CITY OF ALBUQUERQUE

Re: Dunkin
10631 Unser NW
Traffic Circulation Layout
Engineer's/Architect's Stamp xx-xx-xx (A11D017A)

Based upon the information provided in your submittal received 8/23/24, the above referenced plan cannot be approved for Building Permit until the following comments are addressed:

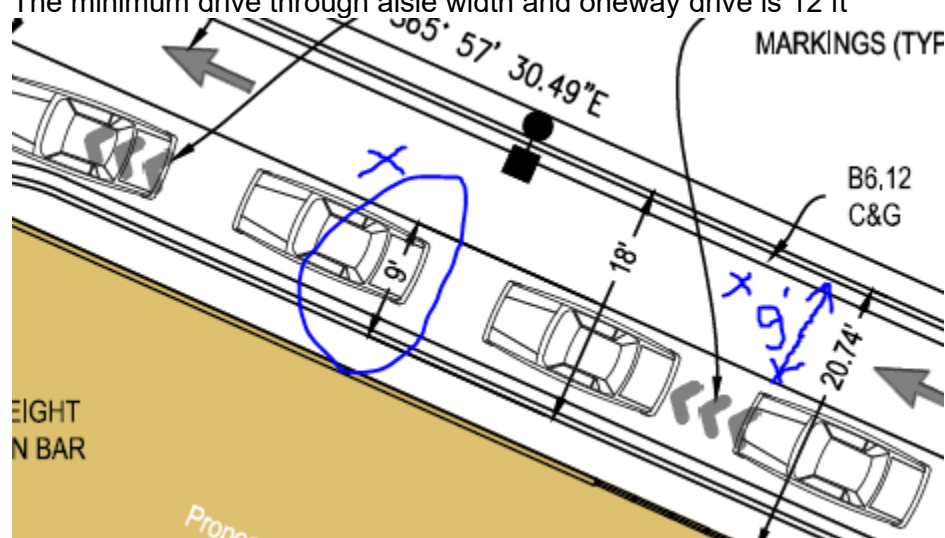
1. Please show a vicinity map showing the location of the development in relation to streets and well known landmarks on site plan C1.1.
2. The traffic circulation layout must be stamped, signed, and dated by an engineer or architect licensed in the state of New Mexico.
3. Show the North Arrow and scale of site plan, a scale of 1"=20' is recommended for sites less than 5 acres.
4. Identify the right of way width, medians, curb cuts, and street widths on Unser Blvd.
5. The minimum parking stall depth is 18.7 ft

6. Motorcycle spaces shall be designated with a posted upright sign, either free standing or wall mounted. Each sign shall be no smaller than 12"x18" and shall have its lower edge no less than 4' above grade.

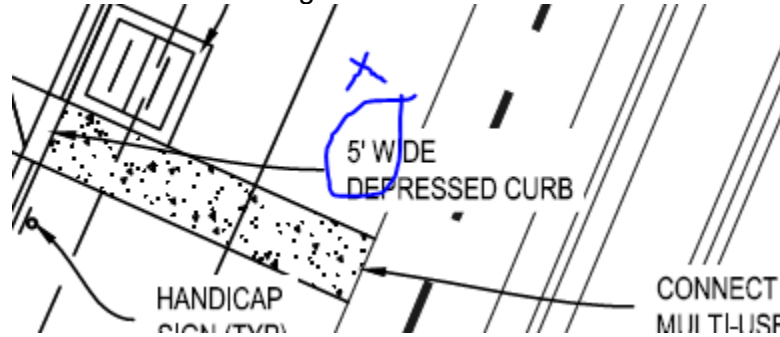
14. The minimum drive through aisle width and oneway drive is 12 ft

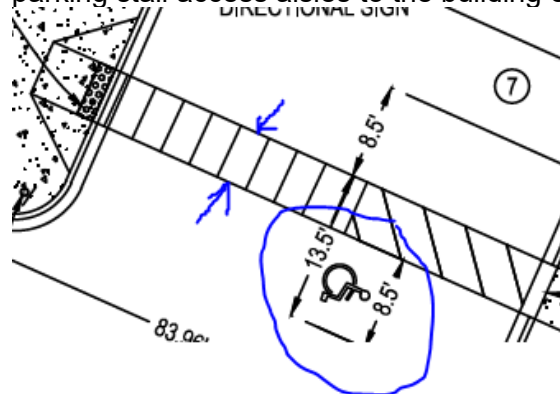
15. Per the DPM, a 6 ft. wide ADA accessible pedestrian pathway is required from the public sidewalk to the building entrances.

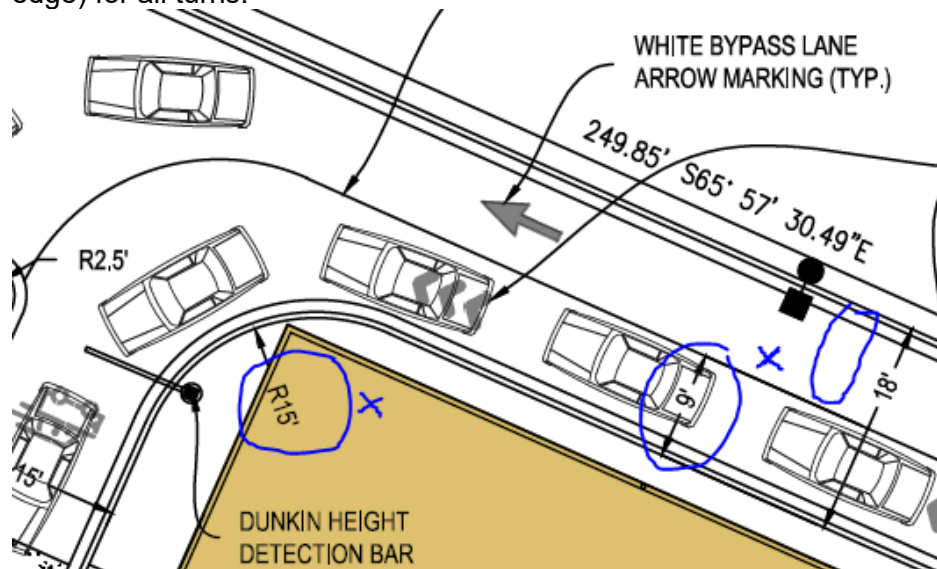
16. Per DPM, a 6 ft. wide ADA accessible pedestrian pathway is required from the ADA parking stall access aisles to the building entrances.

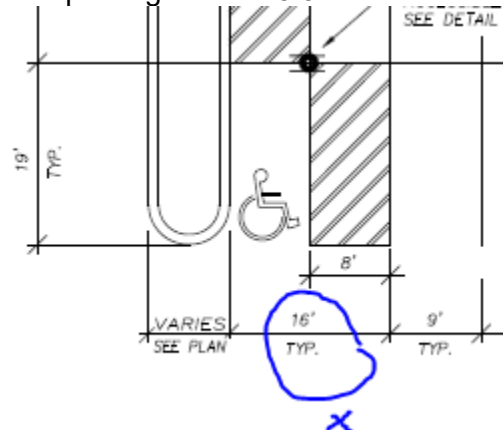
22. ADA parking width is 8.5 ft
